Product Change Notice

Alternate manufacturing site for Bicolor ChipLEDs listed below.

- HSMF-C142
- HSMF-C143
- HSMF-C144
- HSMF-C145
- HSMF-C146
- QSMF-C14T

Description and Extent of Change:

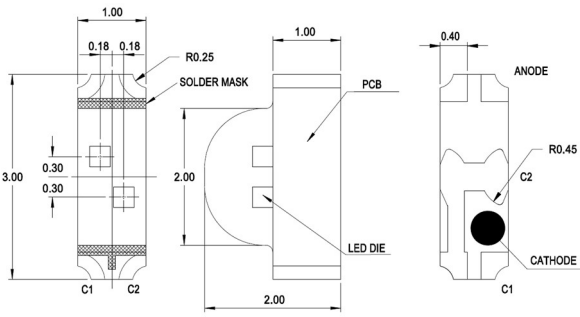
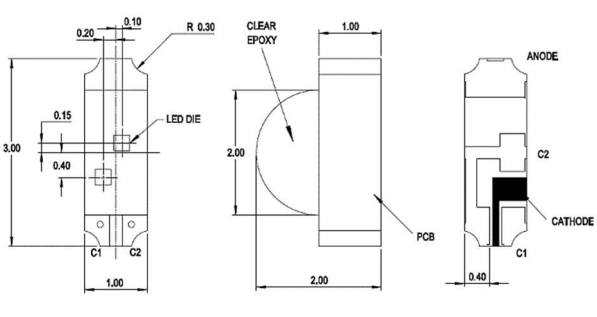
The alternate manufacturing site is qualified per Broadcom’s qualification process.

There is no change in fit, quality and reliability.
